ABOUT ADSP-21371/ADSP-21375 SILICON ANOMALIES

NR003347G

4. 09000013 - Parallel EPROM/FLASH boot following a Hard (Hot) Reset may fail if issued in the middle of external SDRAM reads:

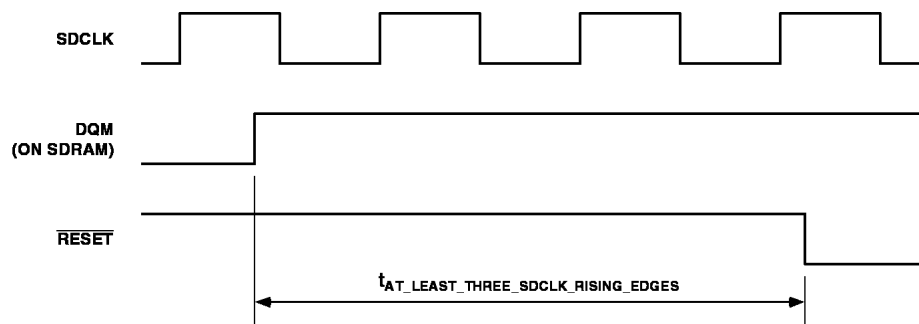
If the processor is in the process of fetching data from external SDRAM memory, or executing code from external SDRAM memory, initiating a Hard (hot) reset during this process may cause the SDRAM device to continue to drive the data bus during the entire duration of $\overline{\text{RESET}}$ being asserted, and also failing to relinquish the external data bus even when the DSP comes out of $\overline{\text{RESET}}$.

If the DSP had been configured to boot via parallel external FLASH or EPROM (which shares part of the same data bus with the external SDRAM), the resulting bus contention on the external data bus between the DSP trying to boot from the FLASH memory and the SDRAM continuing to drive the data bus causes incorrect boot data to be loaded in, and the booting fails. Once the above state is hit, subsequent DSP Resets will not correct the situation. A power-cycling sequence is required to recover from this state.

Providing an external delay of at least 3 SDCLK clock cycles between the SDRAM's DQM signal and the $\overline{\text{RESET_IN}}$ to the DSP will also cause the problem to be avoided (see attached Figure).
